**RECALL CAMPAIGN
INSTRUCTIONS**

REF. NO. C24100080

**REPLACEMENT OF BRAKE FLUID
RESERVOIR CAP**

FERRARI
California **T**

New Adhesive Sticker

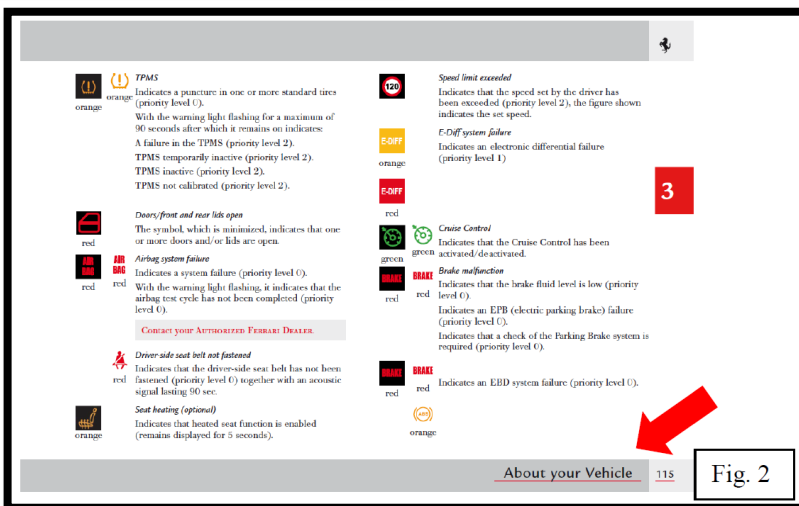
Please find below the proper location and instructions on how to insert the provided sticker into the Owner's Manual (PN: 079641778)

The sticker must be placed on the page shown above in the Owner's Manual. This page is located in the **"About Your Vehicle"** section where the warning lights on the instrument panel are described. Please be sure to attach it to the page with the **"Low Brake Fluid"** description as shown above in Fig. 2.

Once you locate the proper page, remove the adhesive protector off of the back of the sticker. Ensure there is no residue or other particles on the page that may inhibit the longevity of adhesion to the page. Place the sticker to allow the bottom of the sticker to lay directly above the gray margin at the bottom of the page that contains the text **"About your Vehicle"**.

Once applied, apply pressure across the whole strip of 'glue' to confirm the sticker has been properly mated to the page.
